Foam Properties Reconciliation

3-60B Cask Impact Limiters

OBJECTIVE

- To reconcile the differences in the foam properties used by ES in the 3-60B Cask SAR analyses and those derived by the NRC from the General Plastics on-line design guide.

Figure 1 - 17 lb/ft³ at 100°F (ST-551)

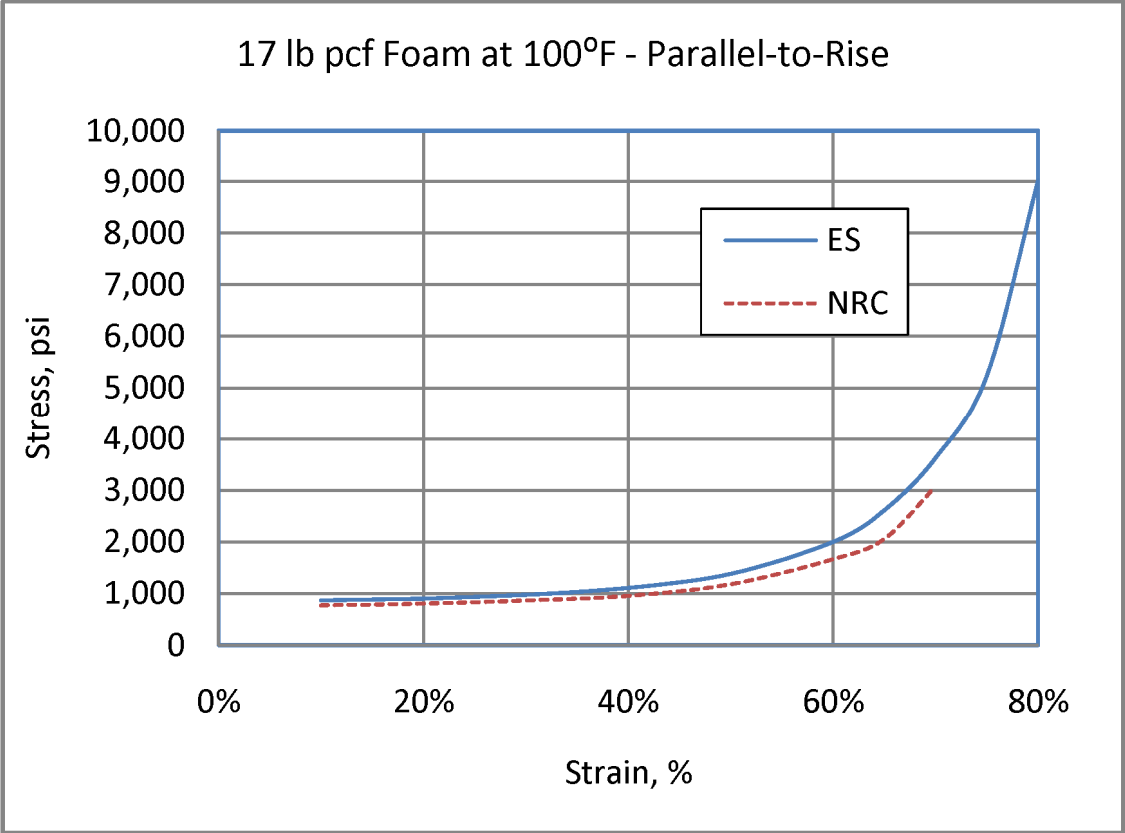
- Using the spread-sheet provided by the NRC, ES produced the "static" stress-strain plots for both 17 lb/ft³ and 25 lb/ft³ foam at 100°F and -20°F (Figures 1 through 4).

- The differences between the ES and the NRC data are minor. The curves are nearly identical for lower strains and deviate slightly for strains between 40 and 70%.
- The ES curves are always stiffer than the NRC curves.
